Metro 78 (LDA20-0066)

(Dec 6, Public Hearing)

Community/Neighbourhood Speaker:

Metro78 West buffer- *purpose and value*

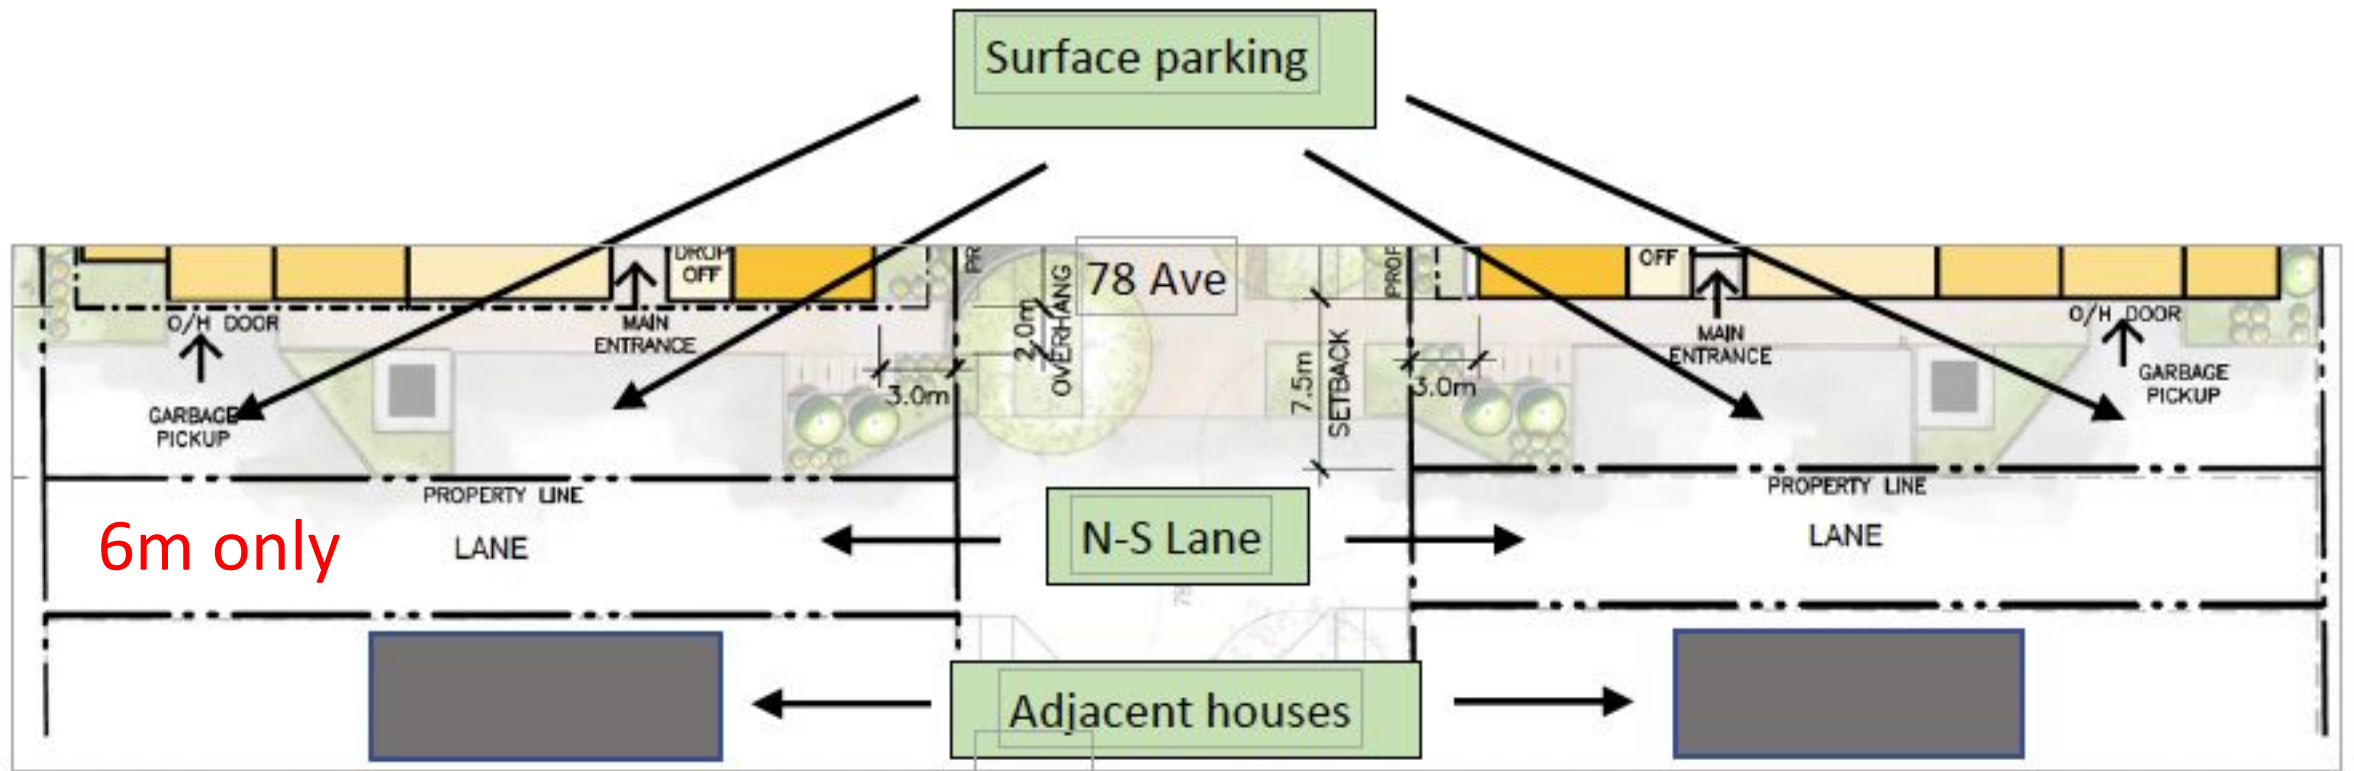
The Metro 78 proposal requires a new N-S lane to be built between 'the development' and the adjacent single detached homes on the west.

- **General vehicle access.** It will connect 78 Ave with the east and west back lanes to allow vehicles access to 115 St
- **Drive-aisle.** Provide access to the Metro 78 surface parking lot.
- **Emergency vehicle access.** Access for emergency vehicles.
- **Sufficient clearance from adjacent homes** (noise, damage, pollution from vehicles to fresh airtakes)

Metro78 West buffer- *does NOT meet standards*

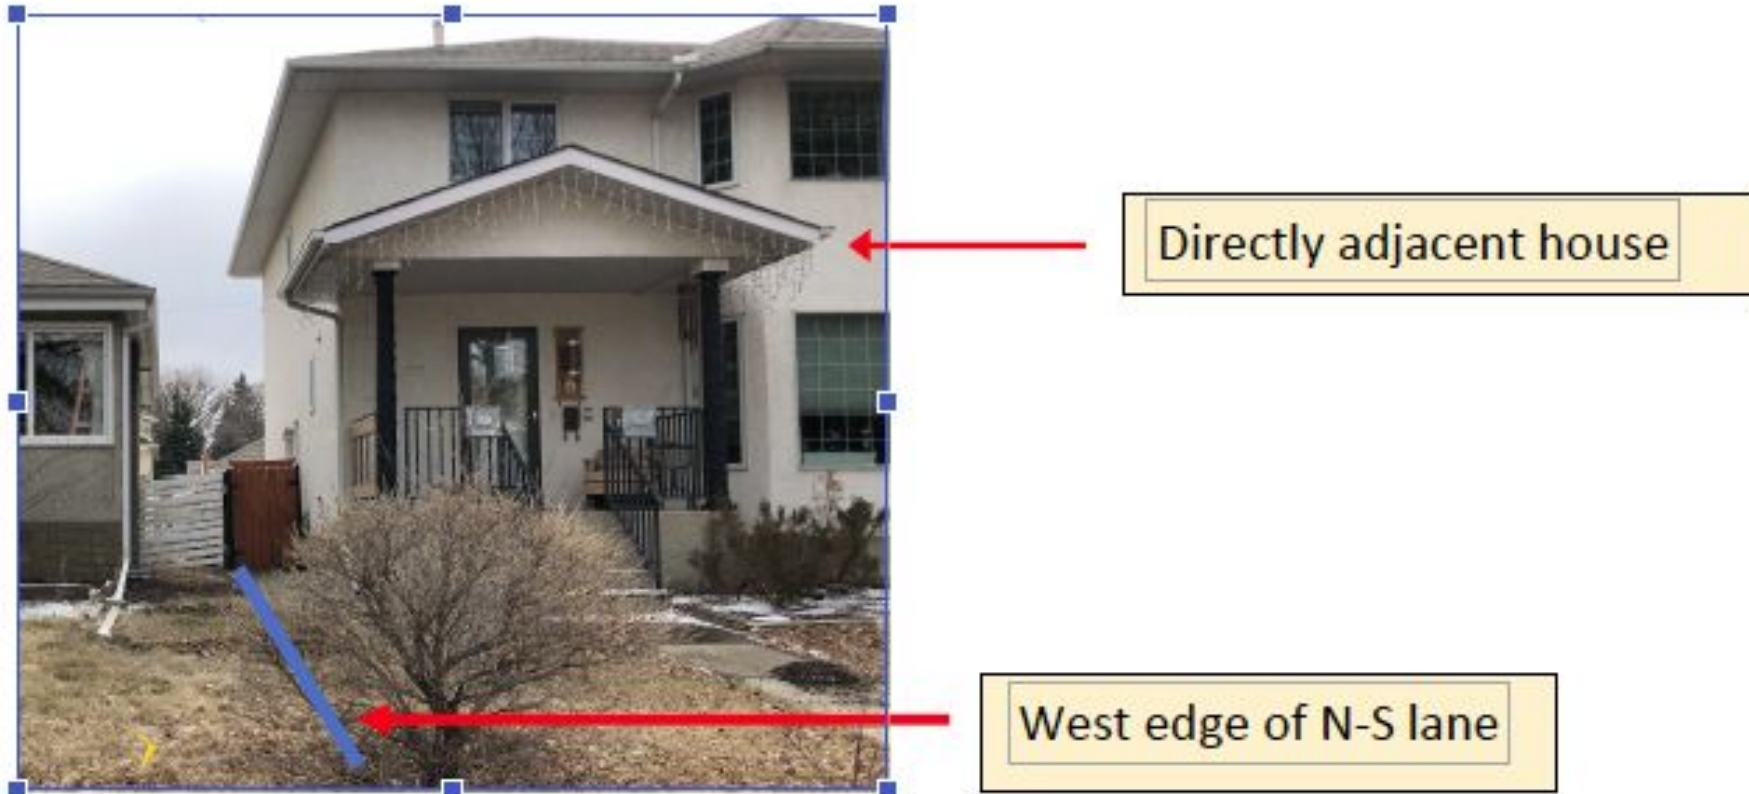
City Design Standards indicate 7.5m for this type of back lane (reverse back lane) to allow for fire trucks (Section 3.9 pg. 170).

City Zoning indicates the drive aisle for a surface parking lot should be 7m (54.1.6.c).

Current design has the N-S lane as 6m- without any justification?

Proximity of adjacent housing to N-S lane is a concern for noise, damage, pollution from vehicles to fresh airtake(s).

Provide a minimum 1m landscape buffer between the N-S lane and adjacent west homes (bring the lane to 7.5m). This will not substantially change the build form and allow for the development to meet standards and be conscious of the surrounding community.
